RE: Amendment to Construction Agreement - Exhaust and Intake Modifications

We are writing to inform you of a necessary modification to our ongoing construction project at the new Carousel Arcade located at 7463 Market St., specifically regarding the new HVAC exhaust and intake locations as shown in the updated architectural drawing sheets dated 02/27/24 and sheets labels A3.0& M1.2 that are attached to this document.

NORTH EXTERIOR ELEVATION
 3/16" = 1'-0"

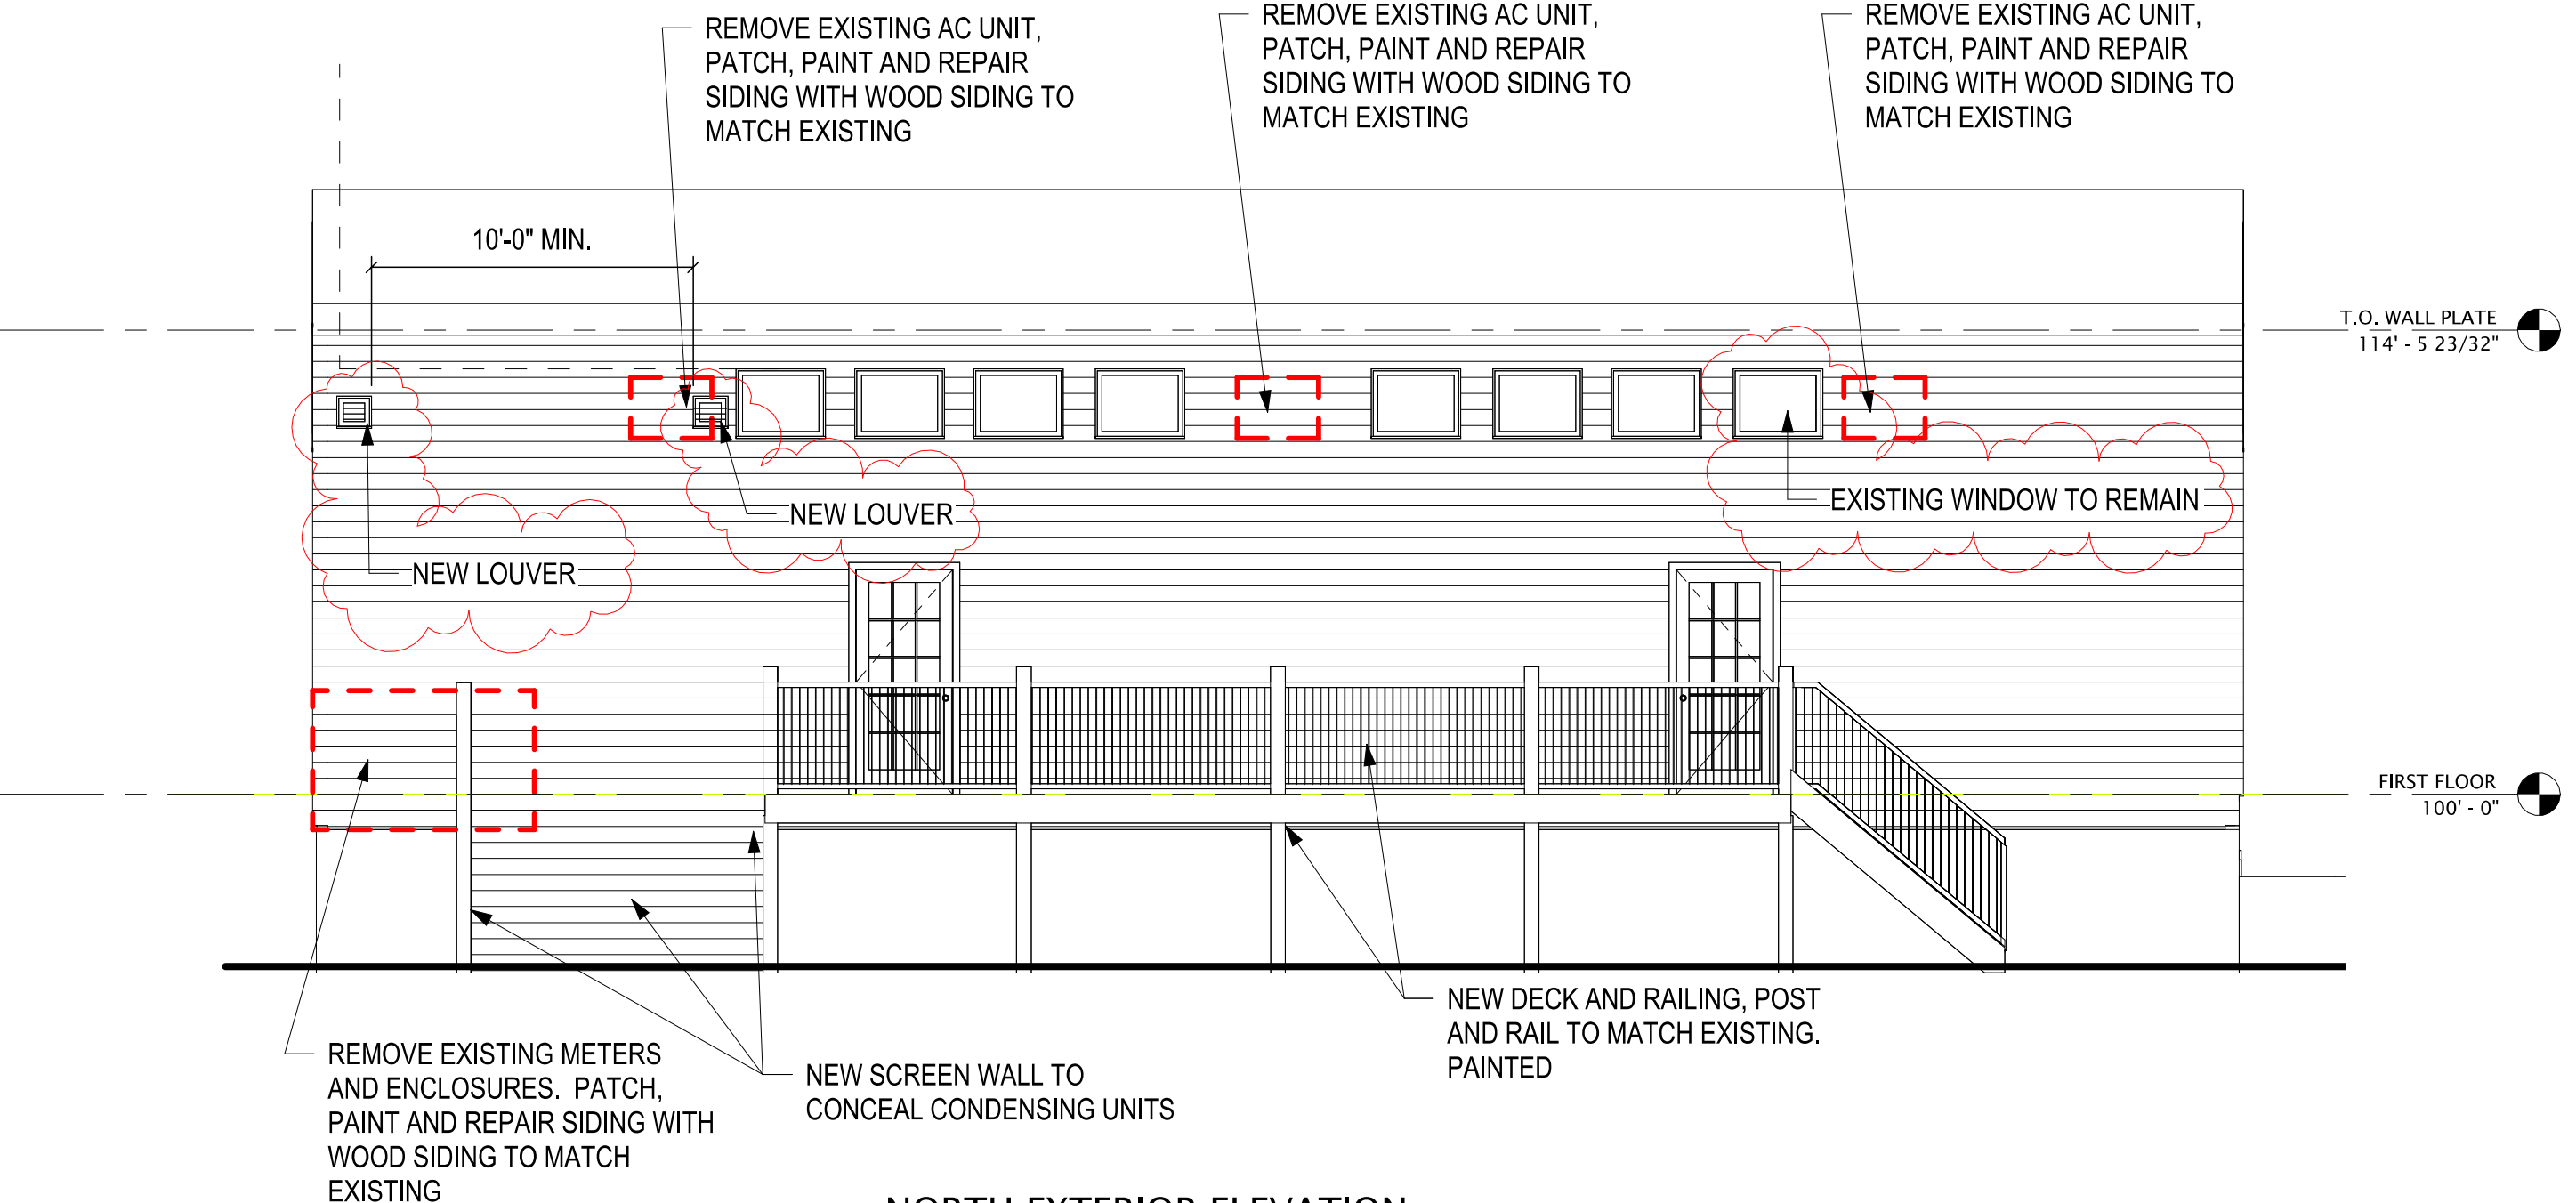
The original permit drawings called for a new HVAC system with the intake and exhaust louvers utilizing existing openings where we removed the old A/C units located on the rear of the building, next to multiple of the existing operable windows, which the owner of the building still plans on utilizing in the future. Upon review of Michigan building code regulations, it has been brought to our attention that the new air exhausts and intake vents cannot be installed near functioning operable windows to be compliant with the state regulations.

1. **Relocation of Exhaust and Intake:** We will relocate the exhaust and intake system to the northeast side of the rear of the building and install per Michigan building code requirements.
2. **Window Modification:** To facilitate the relocation and ensure proper functioning of the system, the window adjacent to the intake will be permanently pinned and sealed closed. This modification is essential to prevent any interference with the system's operation.
